SUBJECT: GRANTING OF TECHNICAL SPECIFICATIONS CHANGE REQUEST 93-28, PEACH
BOTTOM ATOMIC POWER STATION, UNIT NOS. 2 AND 3 (TAC NOS. M89375 AND
M89376)

PEACH BOTTOM ATOMIC POWER STATION, UNIT NO. 2

Amendment No. 199
License No. DPR-44

Amendment No. 201
License No. DPR-56

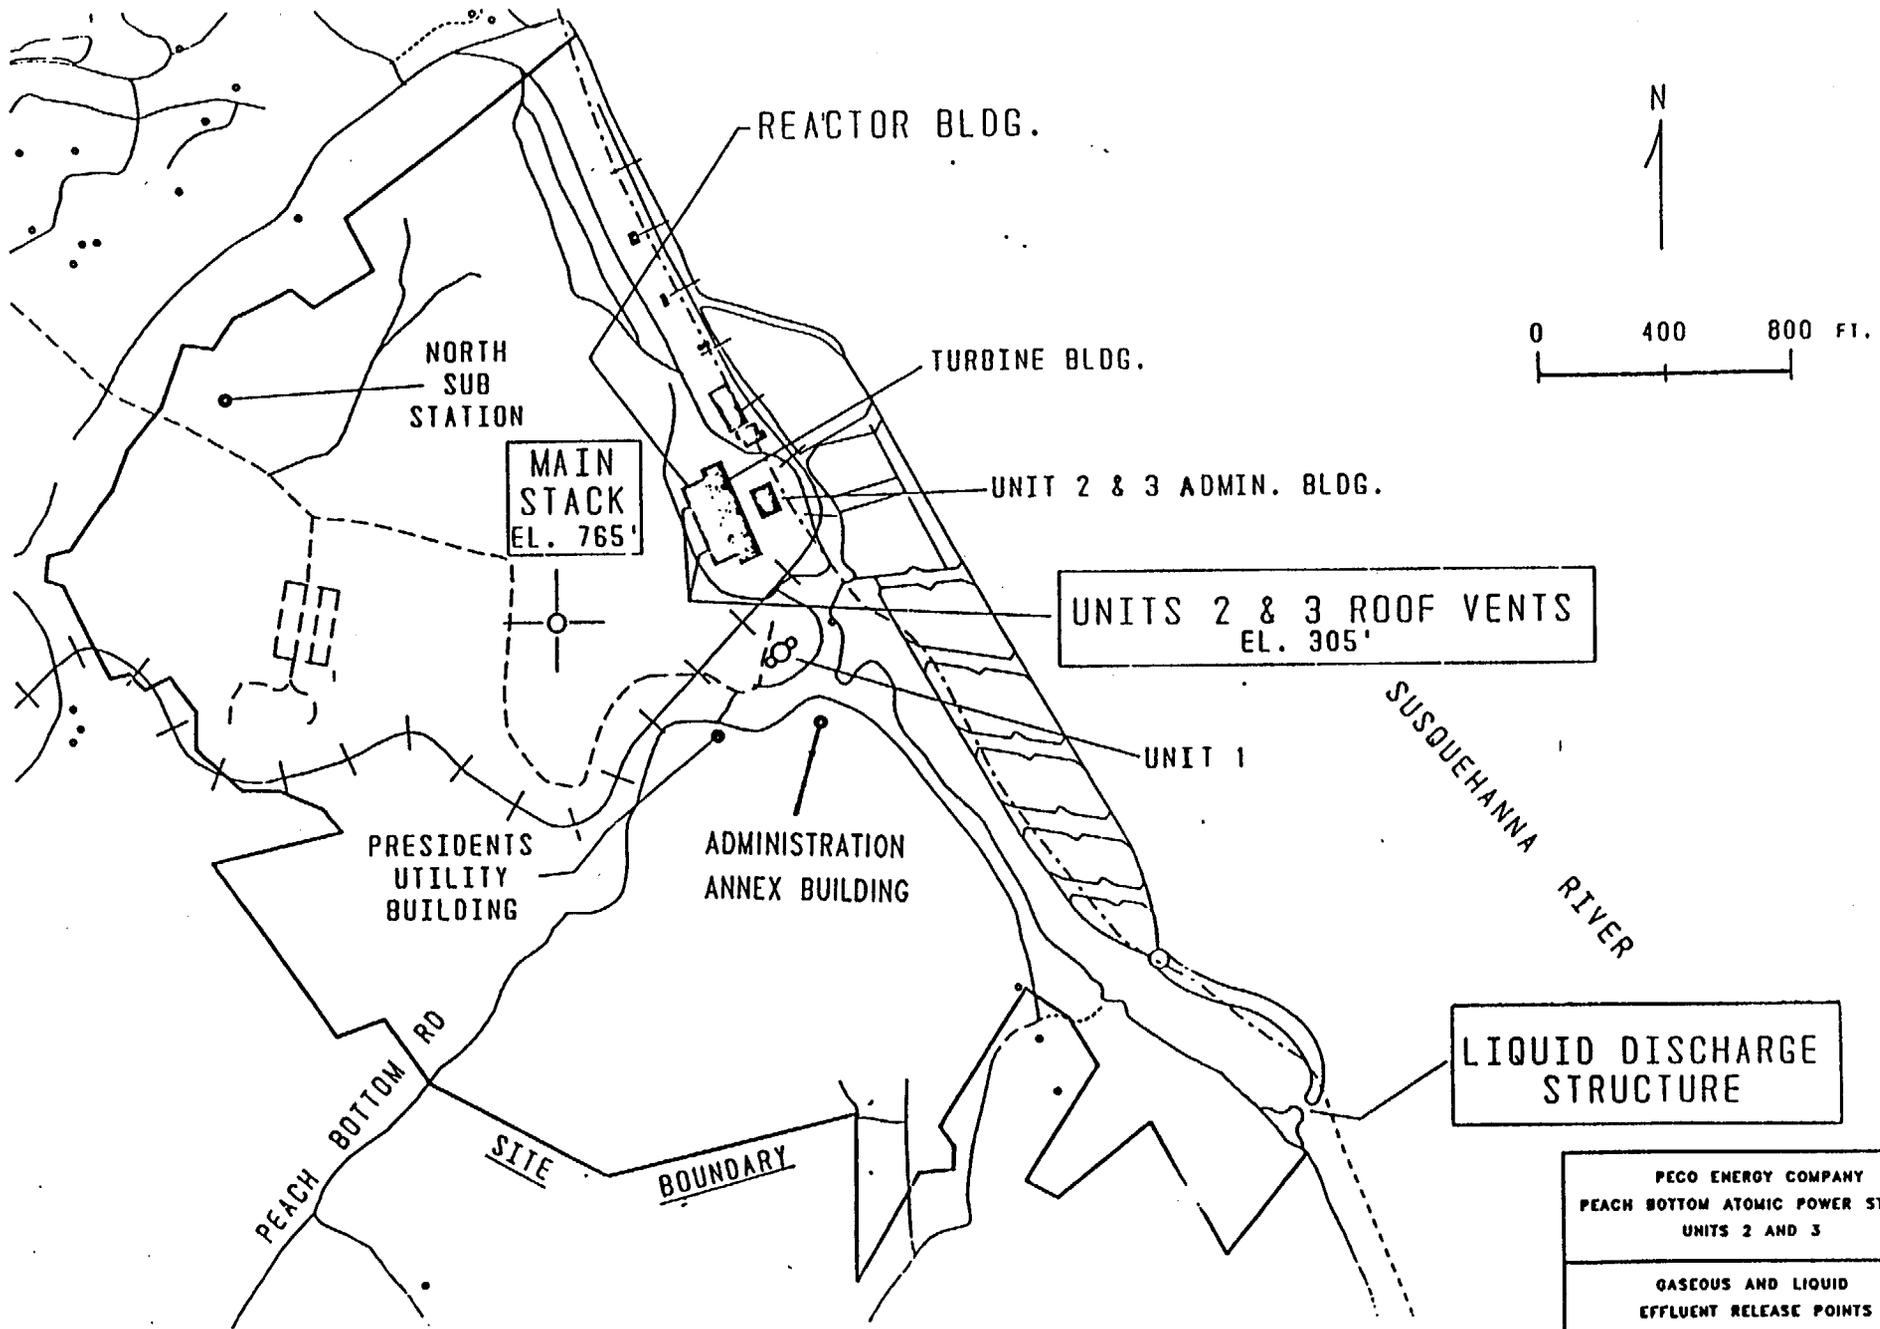
3. Pump Flow Rate: At least once per 92 days each pump loop shall be functionally tested by pumping boron solution to the test tank. At least once per quarter check and record pump flow rate against a system head of 1255 psig.
4. Enrichment: Following each addition of boron to the solution tank, calculate enrichment within 8 hours. Verify results by analysis within 30 days.
5. Solution Volume: At least once per day check and record.

The licensee's third GL 93-05 change request would revise TS Section 4.4.B.3 to functionally test each standby liquid control system pump loop from monthly to at least once per 92 days. Specifically, the licensee proposed to revise "At least once per month..." to "At least once per 92 days...." The staff's GL 93-05, Item 4.3 recommends that the Standby Liquid Control System pump test be required quarterly (i.e., every 92 days), in accordance with the American Society of Mechanical Engineers Code. The staff finds that the licensee's proposal is equivalent to the GL 93-05 recommendation and is therefore acceptable.

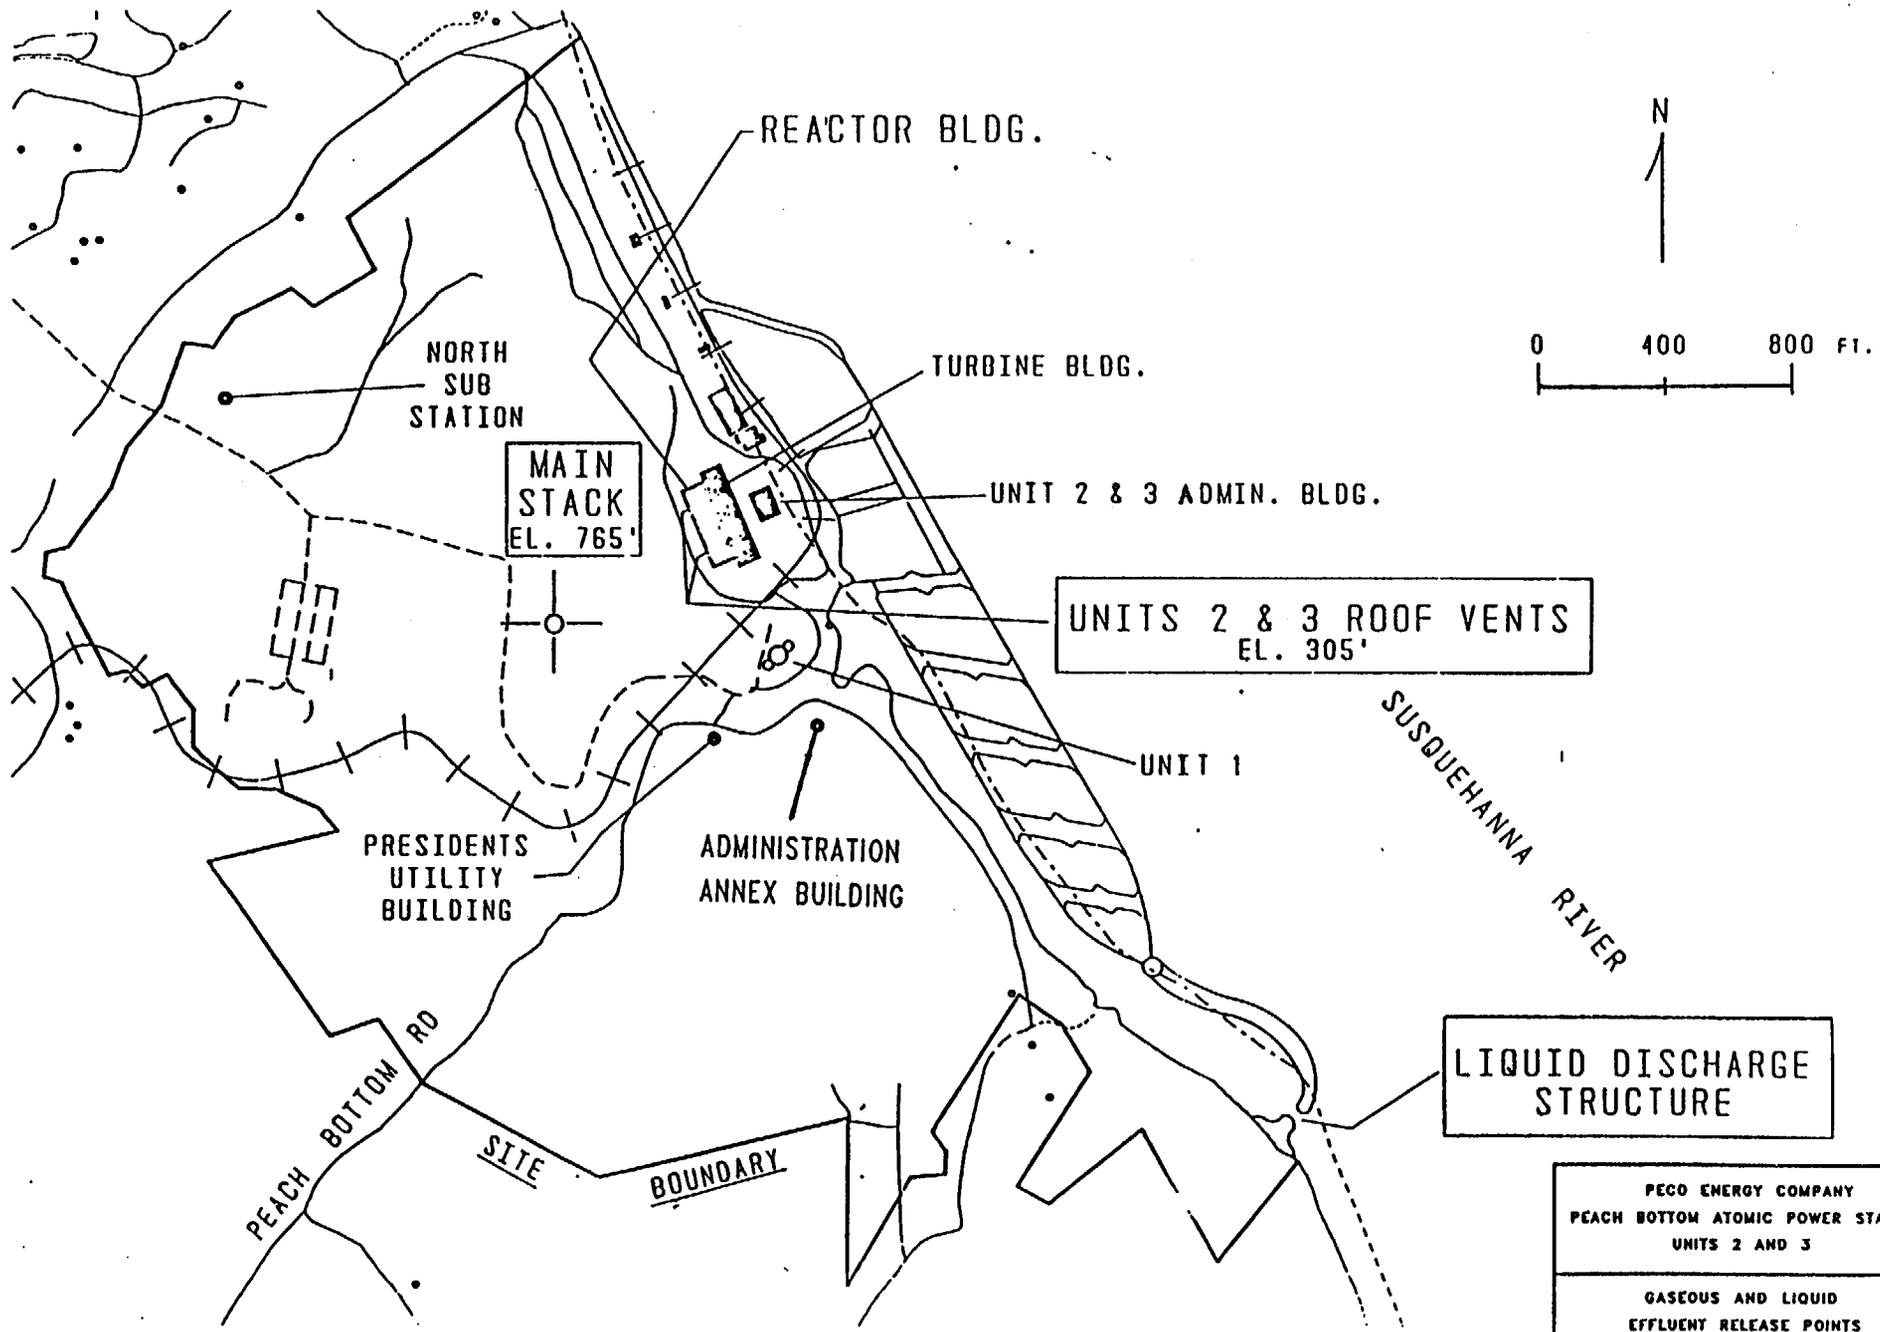
3. Pump Flow Rate: At least once per 92 days each pump loop shall be functionally tested by pumping boron solution to the test tank. At least once per quarter check and record pump flow rate against a system head of 1225 psig.
4. Enrichment: Following each addition of boron to the solution tank, calculate enrichment within 8 hours. Verify results by analysis within 30 days.
5. Solution Volume: At least once per day check and record.
